ALLEGHENY COUNTY SANITARY AUTHORITY

CONTRACT NO. 1735 G, E, H, P

ALCOSAN PARKING GARAGE

ADDENDUM NO. 1

1 LEVEL 2 FRAMING PLAN
S-13 SCALE: 3/32" = 1'-0"

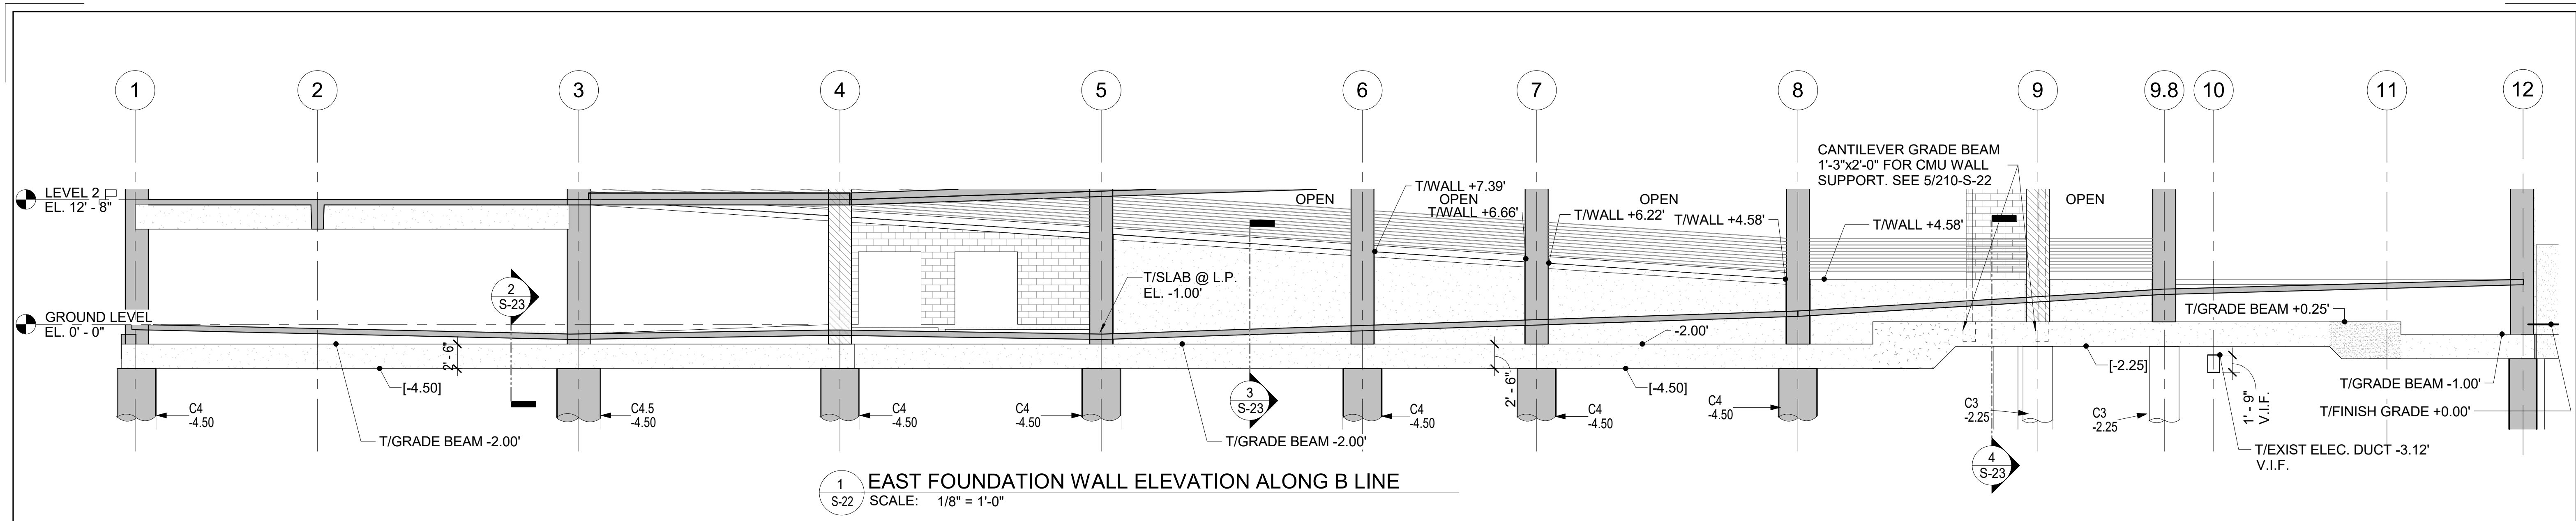
- d. Slab on grade note has been modified.
- 10. Drawing 210-S-13 Level 2 Framing Plan:
 - a. At slab on grade note, ADD: "See drawing 210-SD-01 for typical slab on grade details."

4 SOUTH FOUNDATION WALL ELEVATION AT ELECTRICAL ROOM
SCALE: 1/8" = 1'-0"

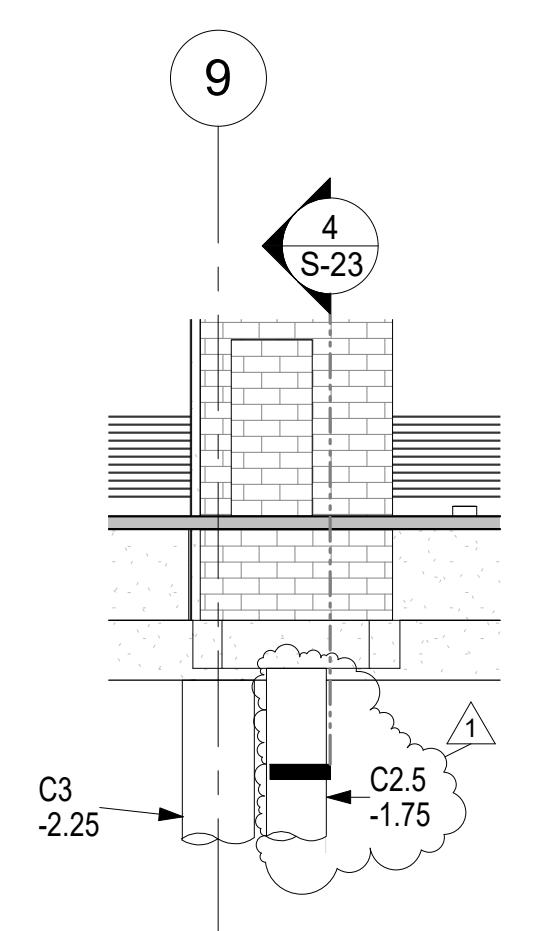
- 11. Drawing 210-S-22 Foundation Wall Elevations:
 - a. REPLACE with the attached drawing 210-S-22.
 - b. Elevations 4 and 5 are modified to show the added C2.5 caisson.

6 FOUNDATION SECTION ALONG 4 LINE
S-23 SCALE: 3/4" = 1'-0"

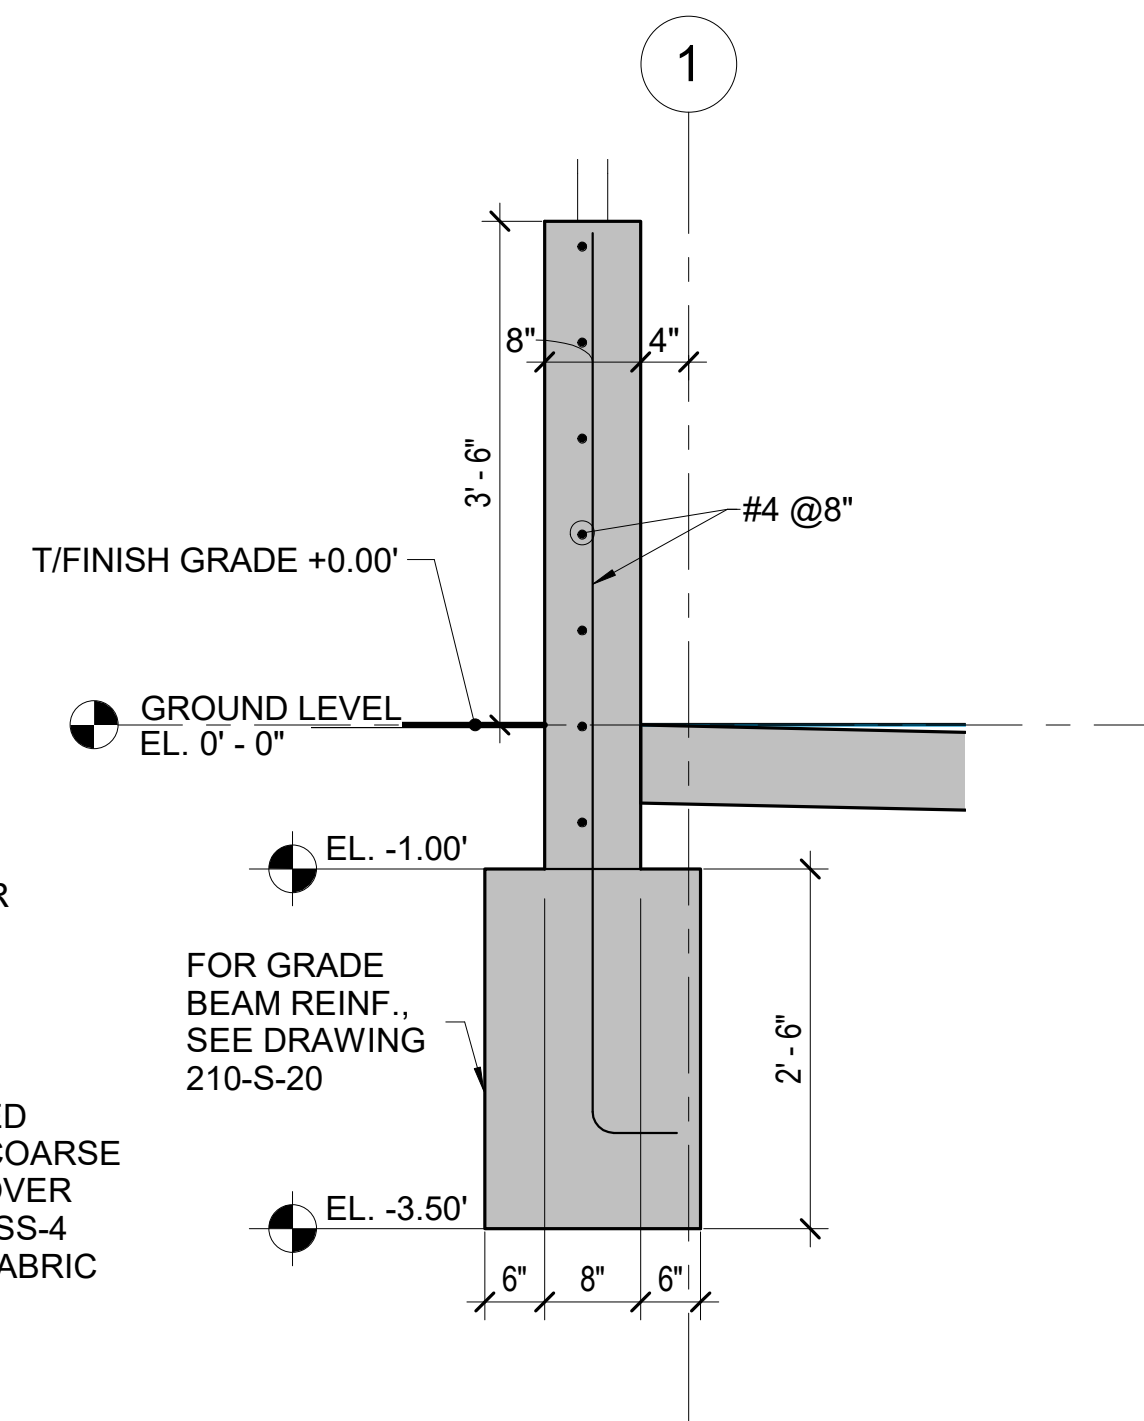
- 12. Drawing 210-S-23 Foundation Sections:
 - a. REPLACE with the attached drawing 210-S-23.
 - b. Section 4 is modified to show the added C2.5 caisson.

5 SECTION AT SUMP PIT
S-34 SCALE: 3/4" = 1'-0"

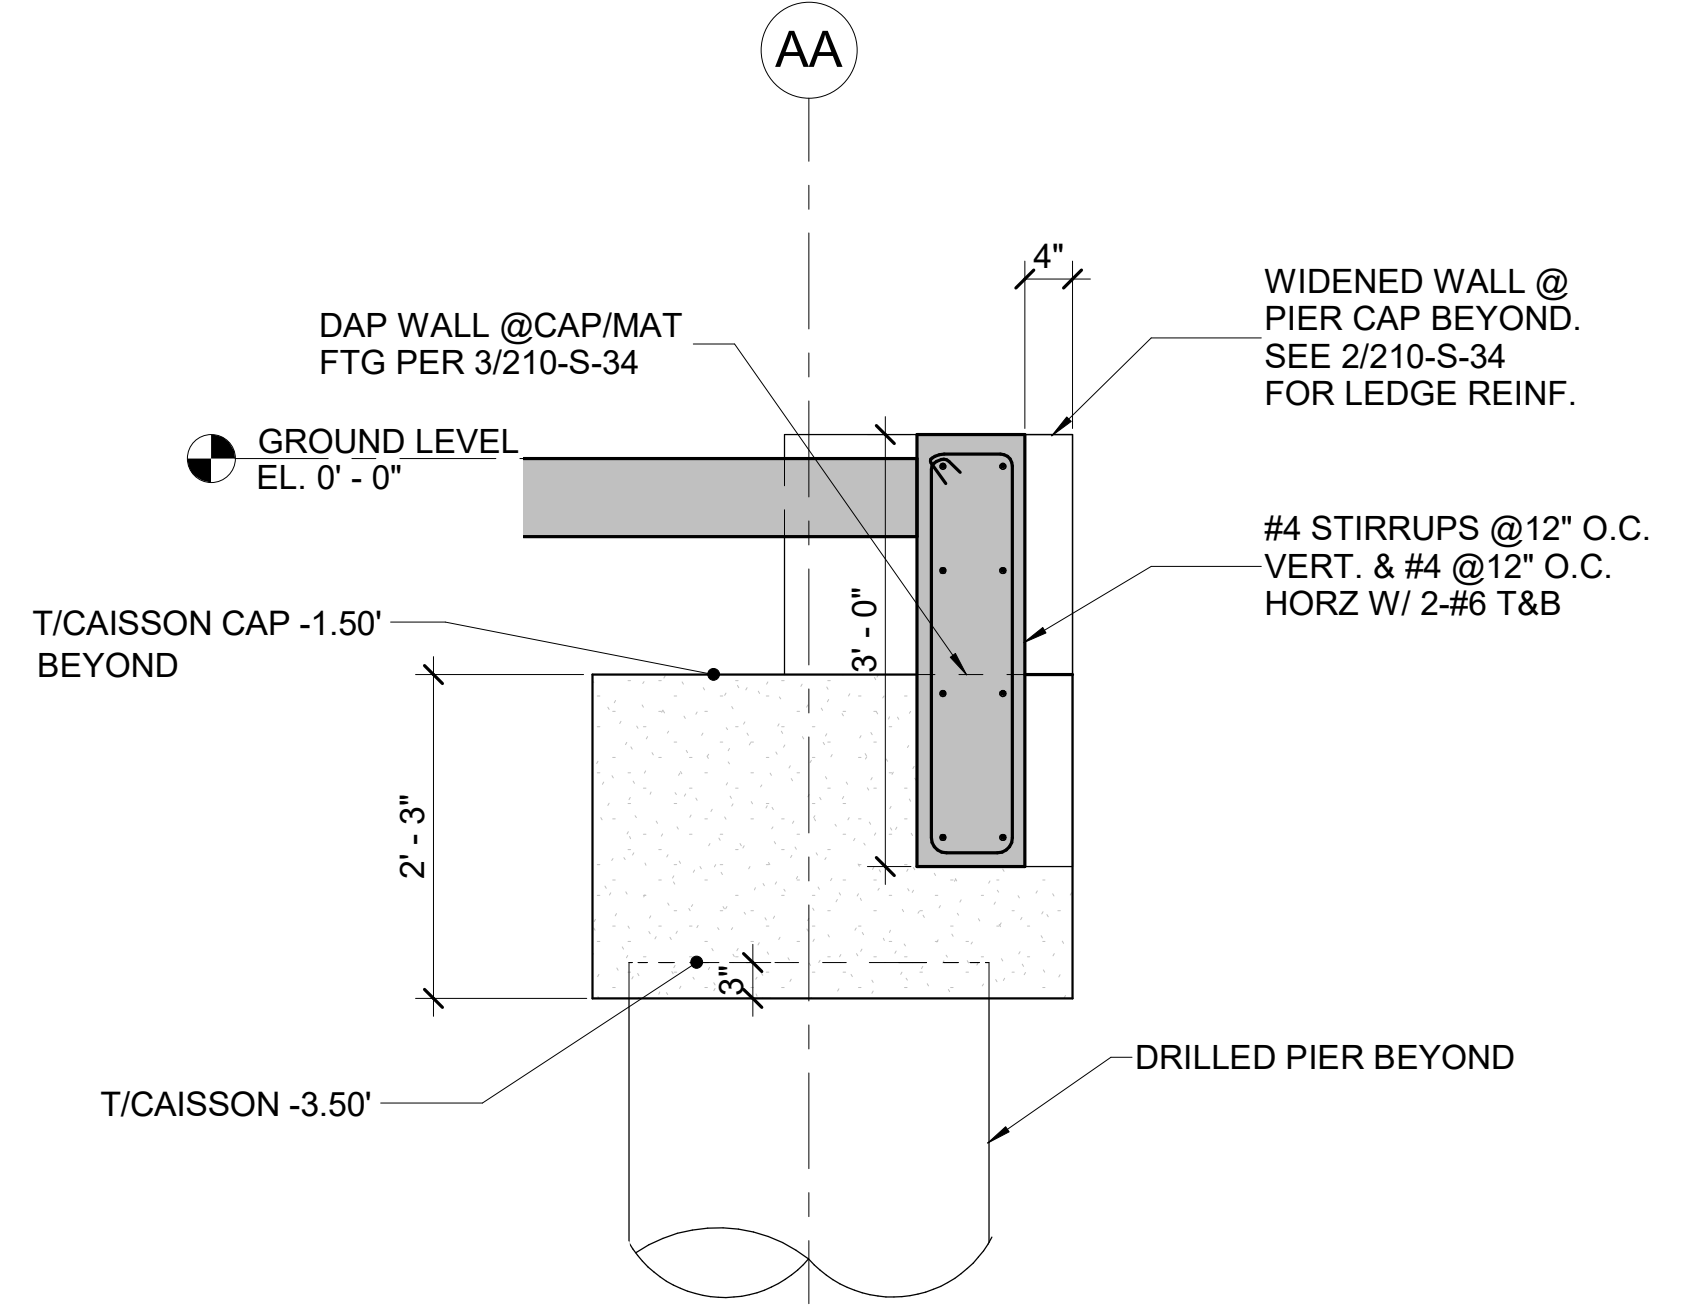
- 13. Drawing 210 S-34 Stair 1/ Elevator Foundation Sections 2:
 - a. In section 5:
 - i. DELETE waterproofing and foundation drain tile. Neither are required in this project.

- ii. DELETE notes:

See Arch for waterproofing.
Drain Tile if req'd. (See Arch.)
- 14. Drawing 210-SS-01 Post-Tensioned Beam Schedule:
 - a. REVISE girder concrete strength to 5 ksi.
- 15. Drawing 210-SS-02 Post-Tensioned Beam Schedule:
 - a. REVISE girder concrete strength to 5 ksi.
- 16. Drawing 210-SD-01 Typical Slab on Grade Details:
 - a. In details 1, 2, 3, 4, 5, 6, 7 and 9, DELETE:
"or vapor retarder (barrier) as appl.,"
- 17. Drawing 210-SS-03 Column Schedule: REVISE all column concrete strength to 5 ksi.

1 TYP. SLAB-ON-GRADE CONSTRUCTION AND CONTROL JOINT DETAILS
SD-01 SCALE: N.T.S.

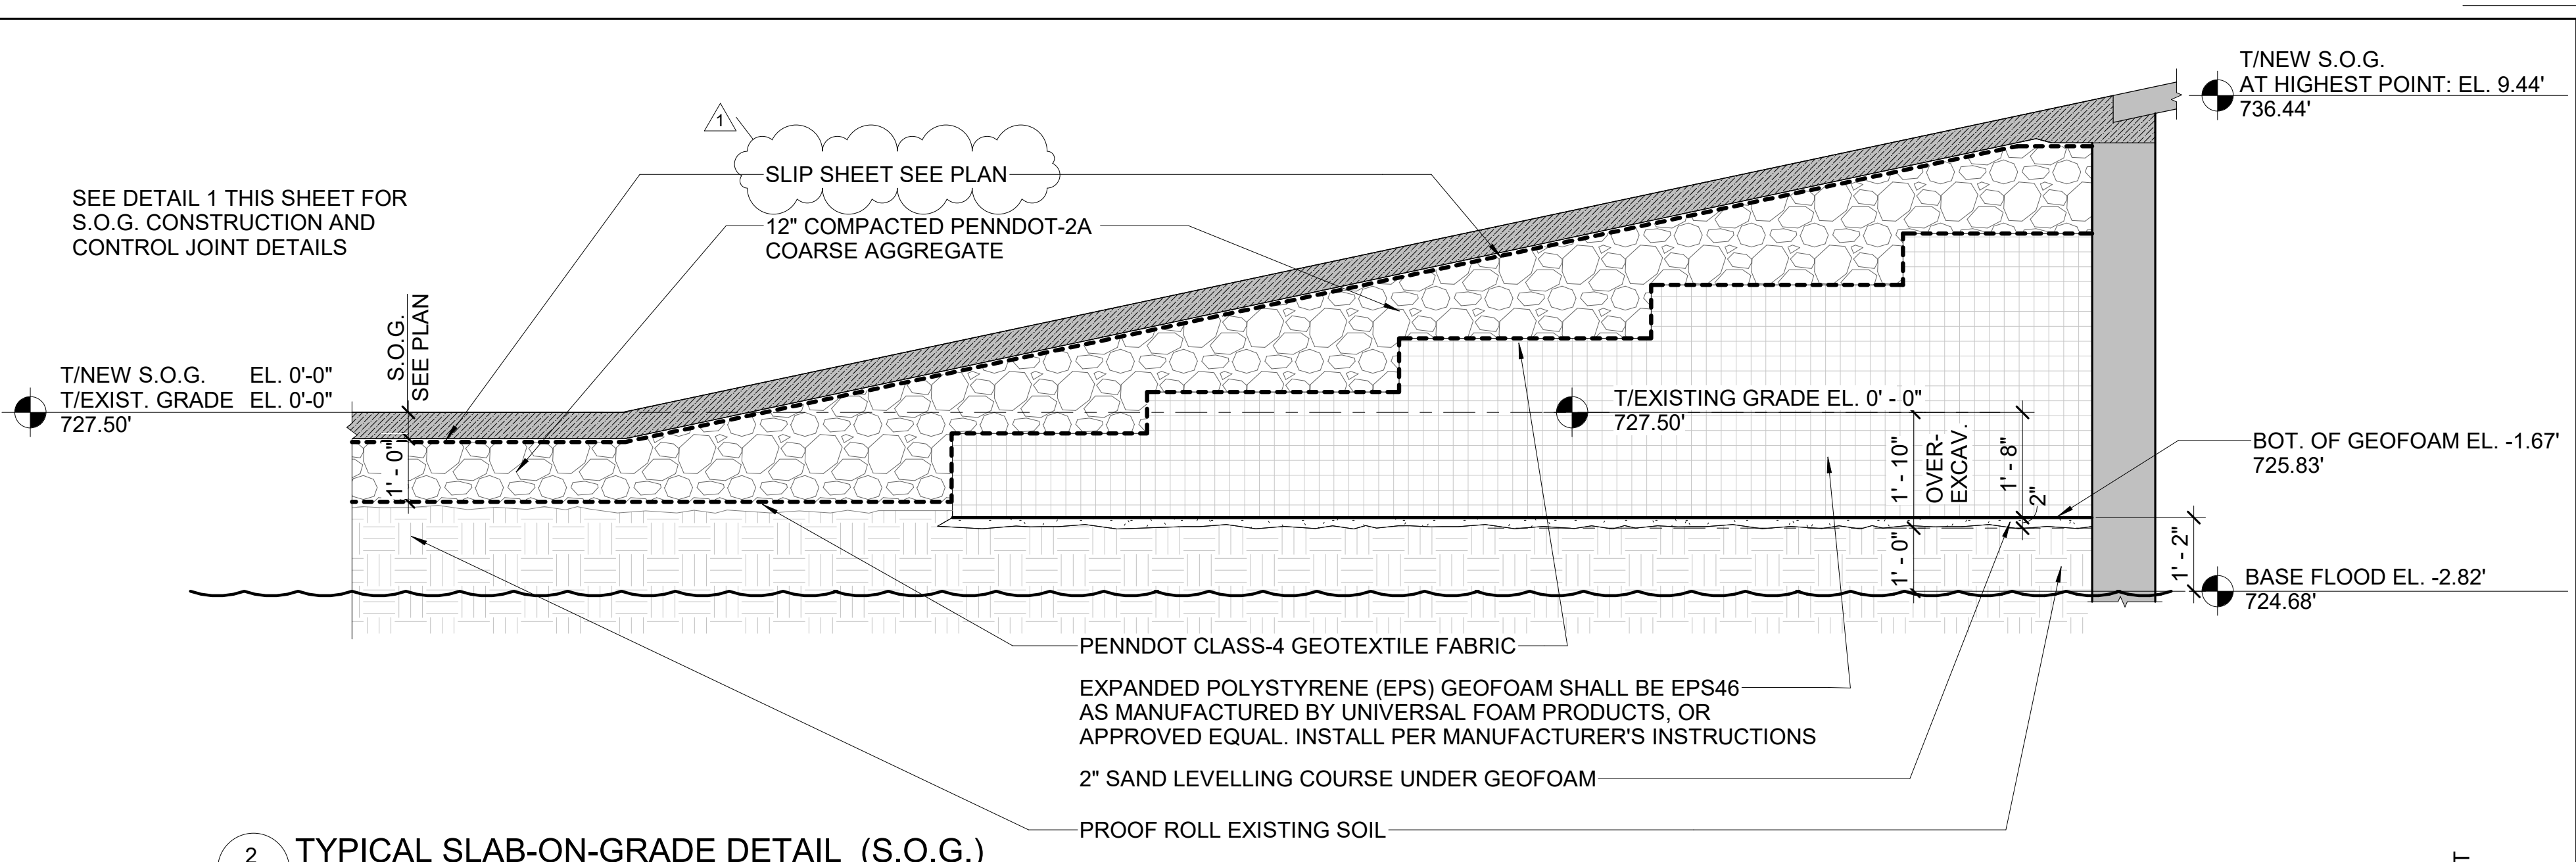
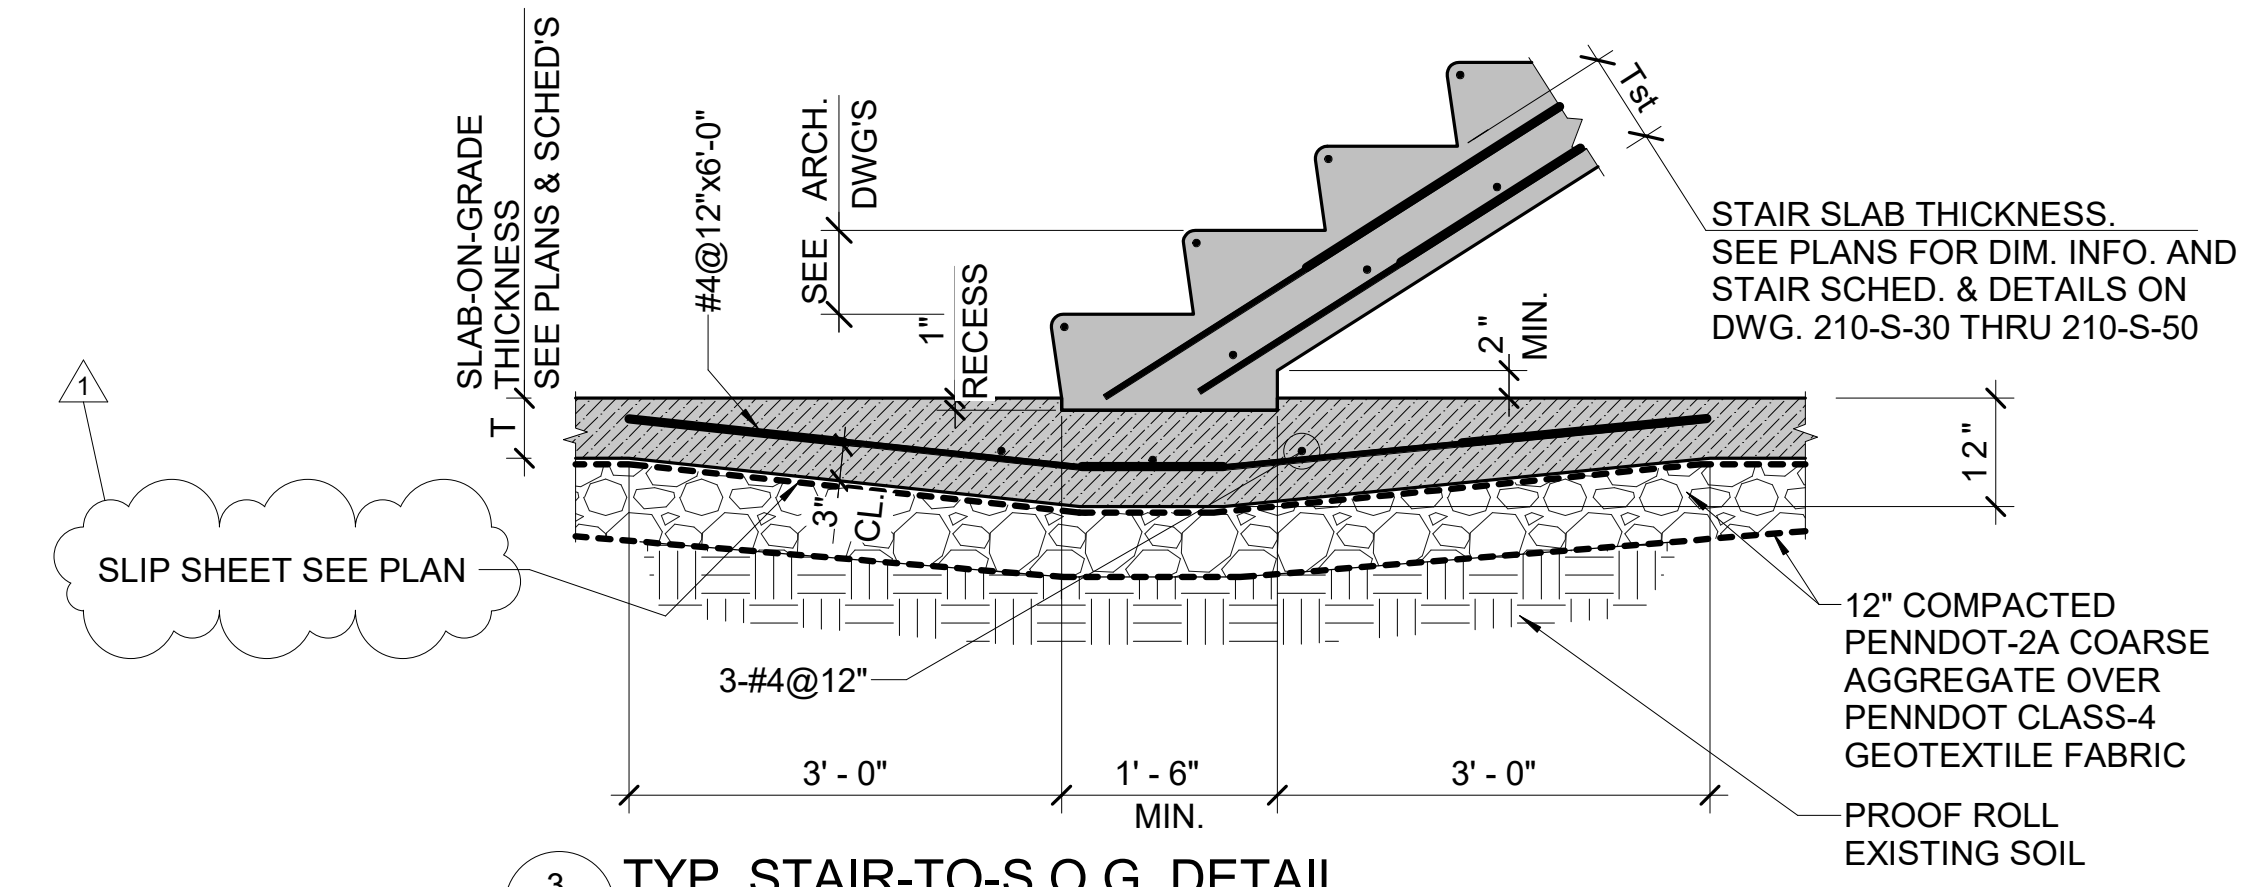
Q13: Drawing SD-01, details 1 & 2 (for example): Indicate “slip sheet or vapor barrier, as appl., see plan.” We see no notations on the structural or architectural plans for either. Please define any areas where a slip sheet or vapor barrier are required. Also, if a slip sheet, please provide a specification.

A13: Provide slip sheet at all slab on grade areas as shown in the details on SD-01. Vapor retarder is not required at any location and has been deleted.

In section 033000 Cast in Place Concrete, delete paragraph, 2.2, I (Under-slab vapor retarder) and replace with:

Slip Sheet: 2 layers of polyethylene sheet, 6 mil minimum thickness, complying with ASTM C171. Prior to installation, when delivered in sheets or rolls, drill a rectangular 12”x12” grid of holes with a 1/8” minimum to 1/4” maximum regular drill bit. Unroll and install over compacted granular backfill. Overlap adjacent sheets by 12” and prevent from slipping by intermittently installed segments of plastic tape 12” to 24” long. Stagger overlaps in plan by at least 2 feet in either direction.
